**Report: TAB REPORT**  
**Function: Test, Adjust, & Balance**  
**Date: 08/01/2024**

**PROJECT**  
**06-17-24 CAVA YUKON, OK (10TH ST)**

Project: 06-17-24 CAVA YUKON, OK (10TH ST)

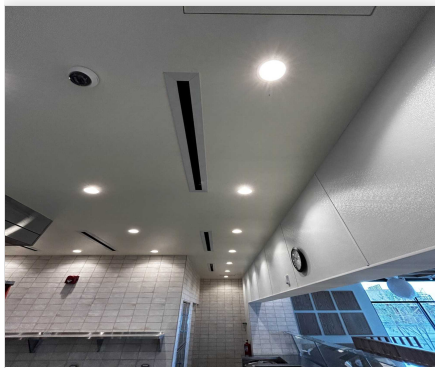
**Issue Name :** EF2 - AIRFLOW  
**Description :** FAN IS ON HIGH AIRFLOW, NO FAN SPEED CONTROLLER INSTALLED. RECOMMEND INSTALLED SPEED CONTROLLER TO BRING FAN INTO DESIGN.  
**Created By :** National TAB                      **Assigned To :** National TAB - Will Turnbough  
**Status :** Open  
**Priority :** Urgent                                      **Asset Tag :**  
**Originated Date :** 06/19/2024 - Kristopher Passley - National TAB

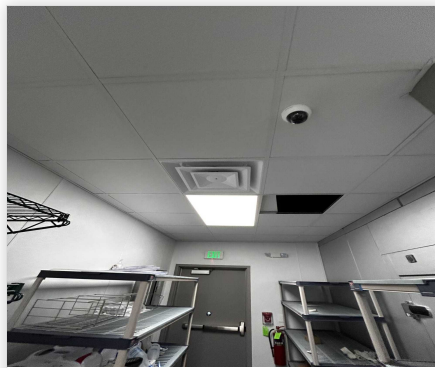
**Issue Name :** RTU-1 KITCHEN DIFFUSERS  
**Description :** KITCHEN DIFFUSERS 1-1,1-2,1-3 and 1-8 HAVE CLOSED DAMPERS THAT ARE INACCESSIBLE. NEED MECHANICAL TO OPEN OR CHECK FOR BLOCKAGE.  
**Created By :** National TAB                      **Assigned To :** National TAB - Will Turnbough  
**Status :** Open  
**Priority :** Urgent                                      **Asset Tag :**  
**Originated Date :** 06/20/2024 - Kristopher Passley - National TAB

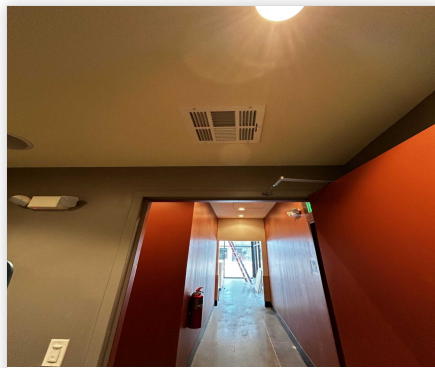
**Issue Name :** RTU-2 DIFFUSERS  
**Description :** RESTROOM AND HALLWAY DIFFUSERS 2-11, 2-12 and 2-14 HAVE CLOSED DAMPERS THAT ARE INACCESSIBLE. NEED MECHANICAL TO OPEN DAMPER OR CHECK FOR BLOCKAGE.  
**Created By :** National TAB                      **Assigned To :** National TAB - Will Turnbough  
**Status :** Open  
**Priority :** Urgent                                      **Asset Tag :**  
**Originated Date :** 06/20/2024 - Kristopher Passley - National TAB
